**TOWN OF CARMEL**  
**PLANNING BOARD**

**PLANNING BOARD AGENDA**  
**AUGUST 26, 2015 – 7:00 P.M.**

Town of Carmel Planning Board  
CRO-420 FAD-Related Stormwater Control/Management at Drewville Road  
Town of Carmel, Putnam County  
July 30, 2015

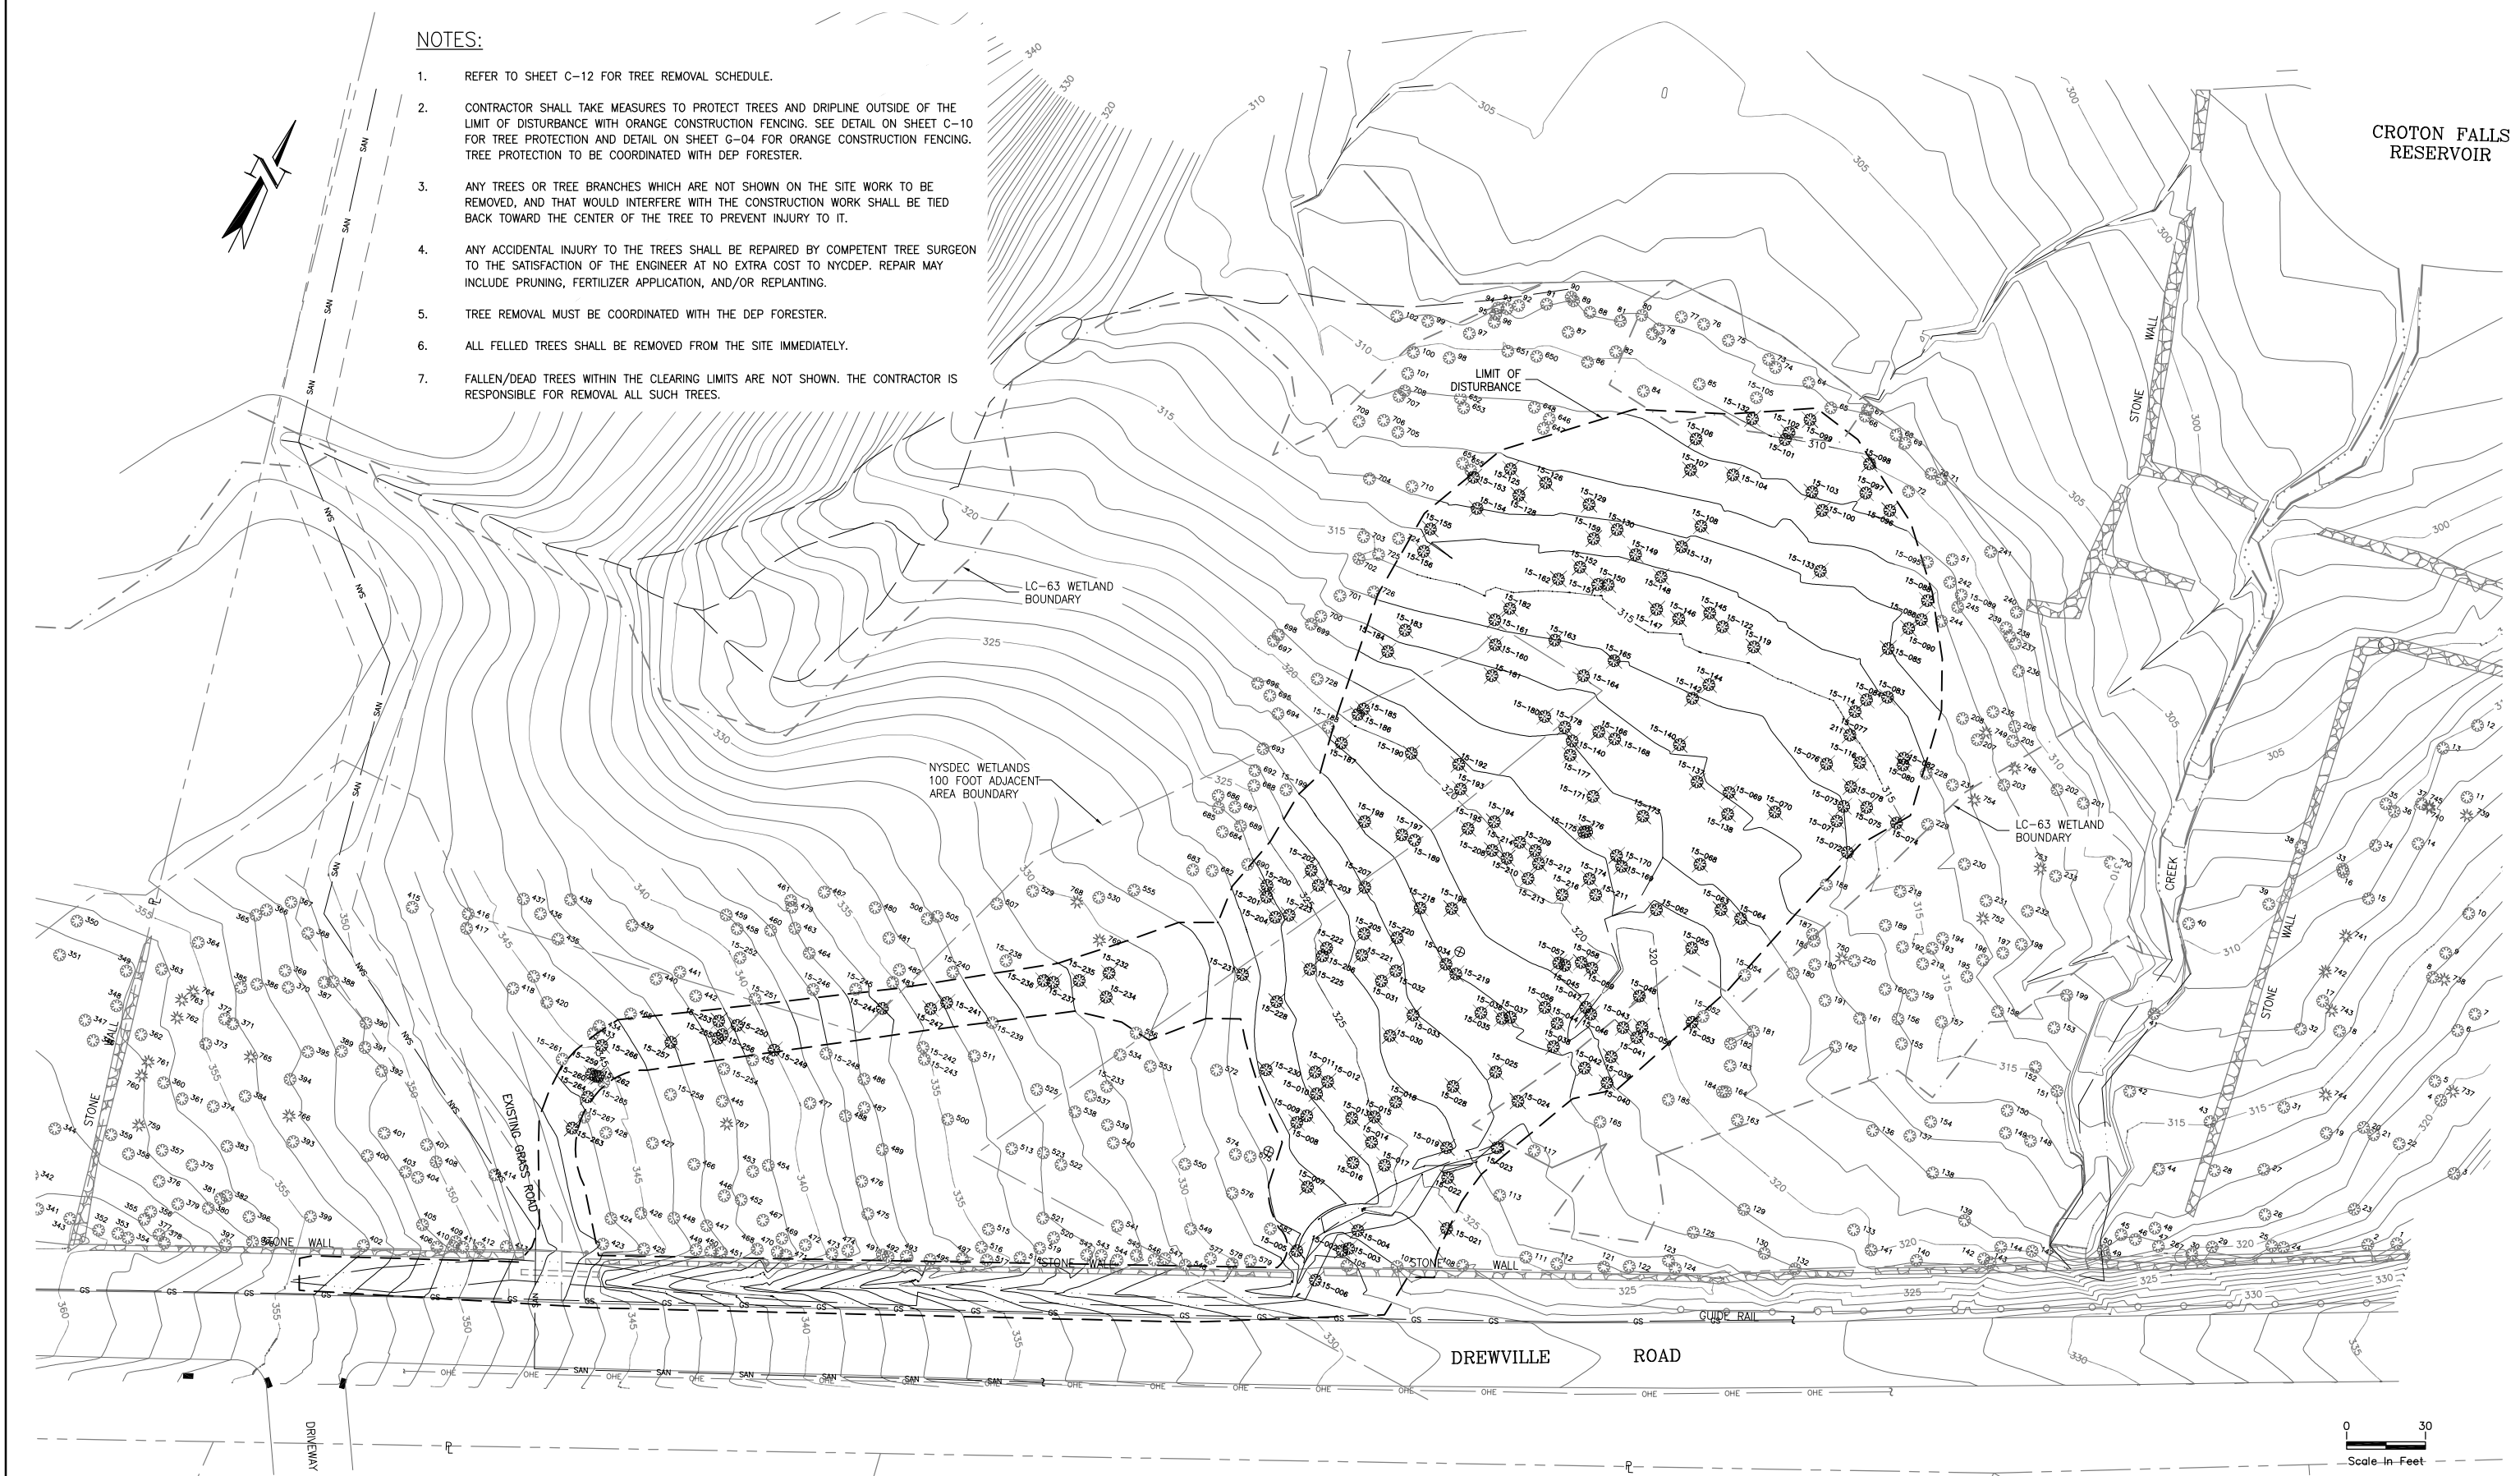
1. I recommend that the applicant provide the name of the tree removal contractor chosen to perform the work with a detailed explanation of the anticipated tree removal process and time frame for the work.
2. I recommend that I receive notification when the tree removal work is starting and I will make a site inspection of the work during the process.
3. I recommend a final inspection of the project when all reclamation is completed to confirm that all work was completed as proposed, and that the work sites are left in a safe and environmentally sound manner.

**ZARECKI & ASSOCIATES, L.L.C.**  
 Consulting Engineers - Land Surveyors - Architects  
 11 South 10th Street, Putnam NY 12548  
 518.533.2777  
 4 OF 9

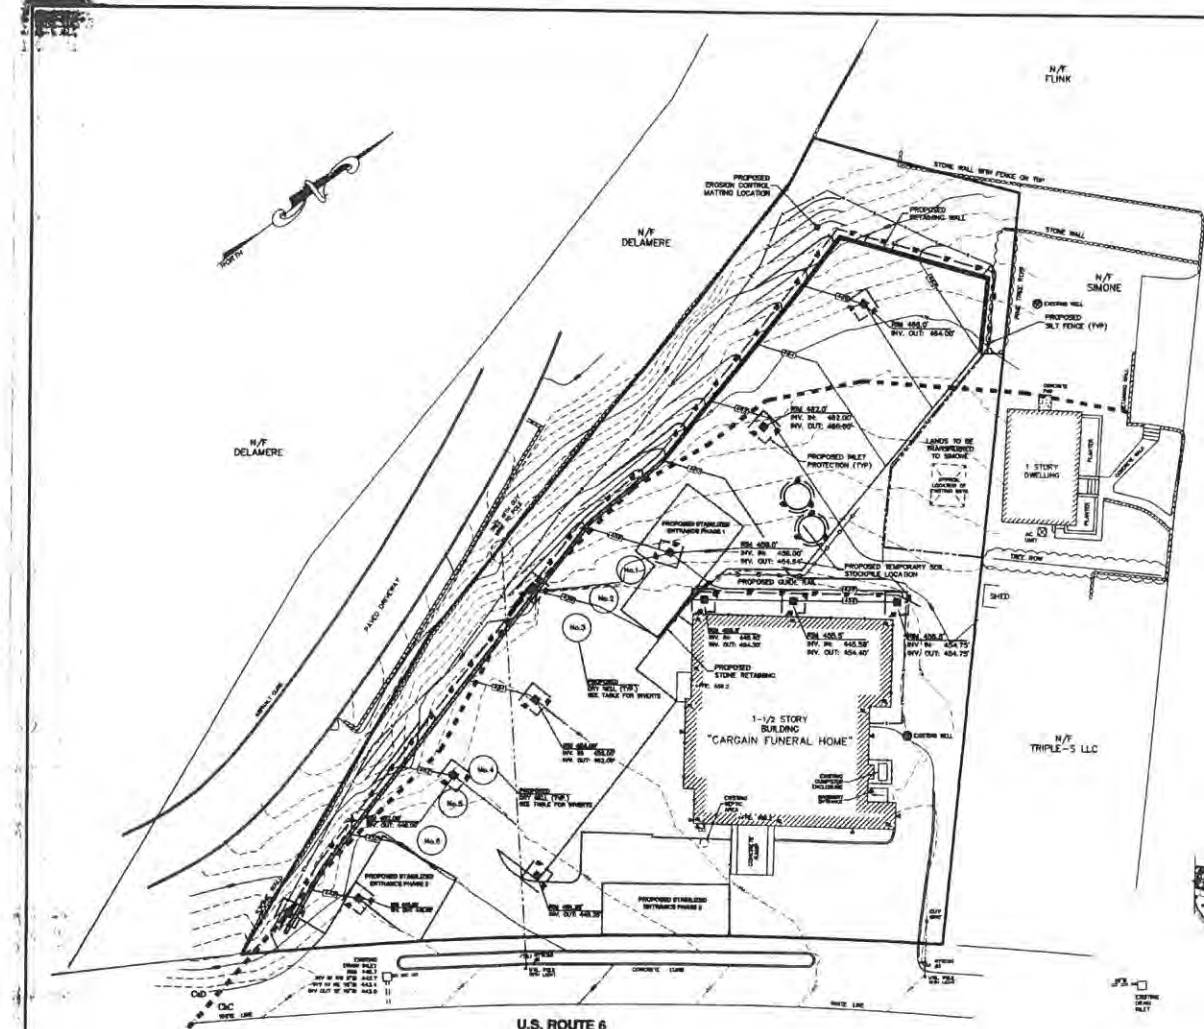
9. Design details for the dry well should be provided. This includes but is not limited to the location and amount gravel being used.  
**Response: As requested, details have been provided for dry wells on the Grading & Utility Plan, Sheet 4 of 9.**

11. Invert of the existing Storm drain on Route 6 should be provided to ensure that the proposed drainage will work.  
**Response: The invert has been provided on the Grading and Utility Plan, Sheet 4 of 9.**

**RETAINING WALL PLAN**

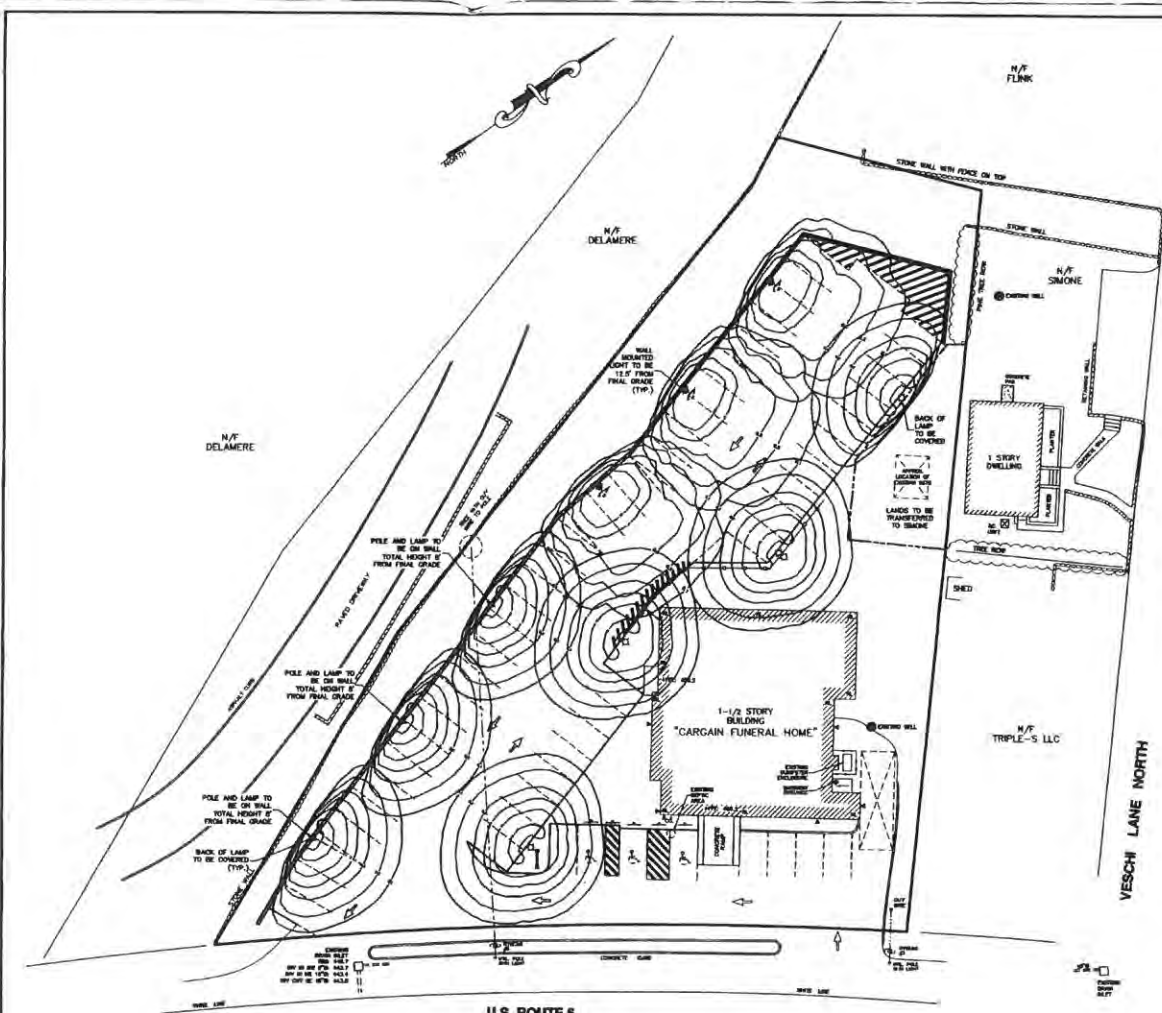
- Provide a setback line at the retaining wall to insure compliance with zoning. Any wall 6 ft. tall or more must meet the setback requirements.  
**Response: See Retaining Wall Plan, Sheet 6 of 9, showing the setback line which in is compliance with the zoning requirements.**

9 OF 9

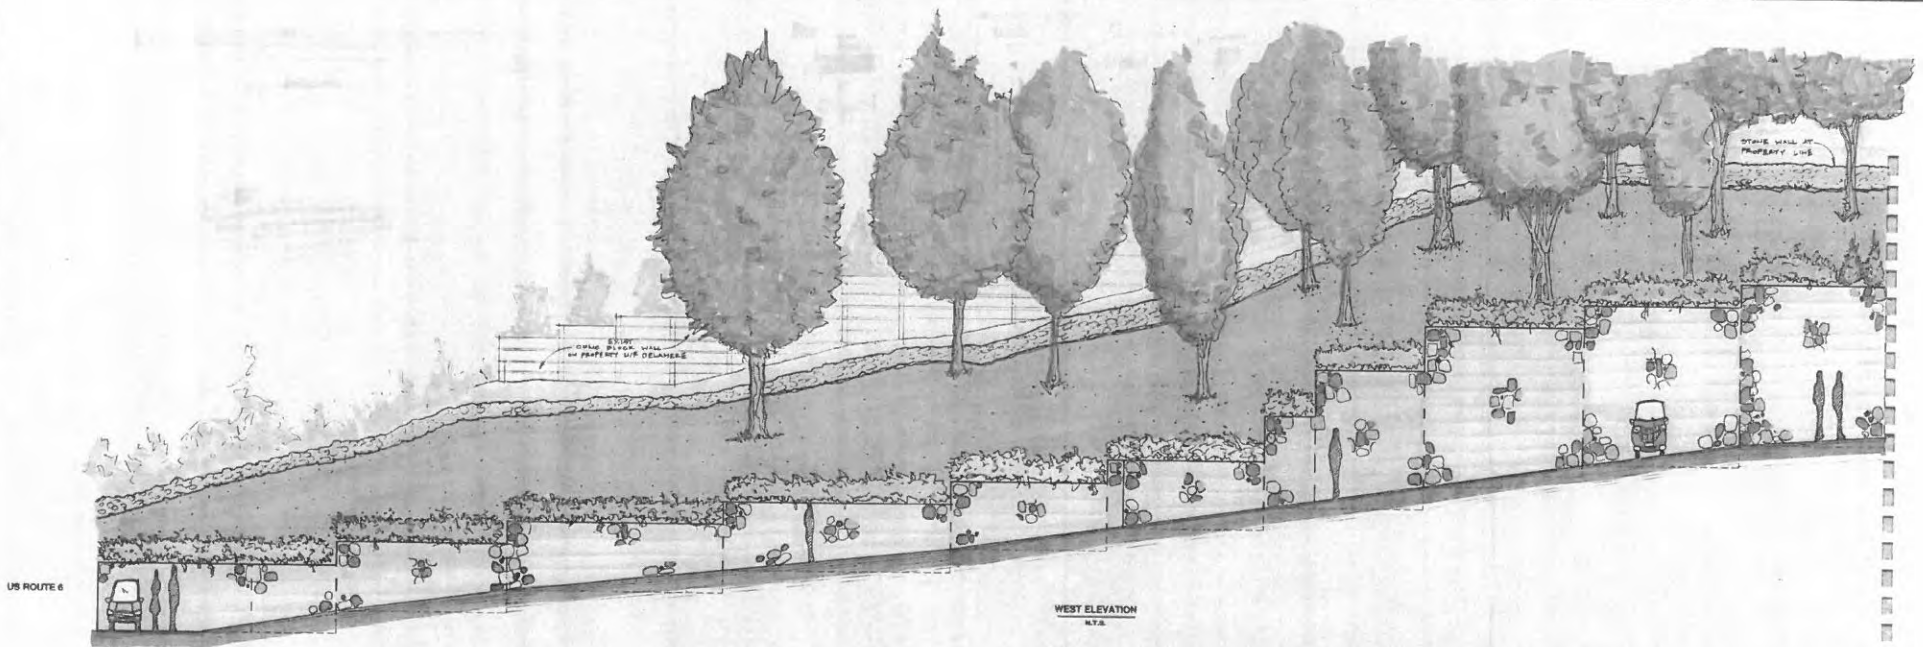
16. Construction sequence information should be provided on the drawings.  
**Response: Please note that a Construction Phasing Plan have been added to the drawing set, Sheet 9 of 9.**
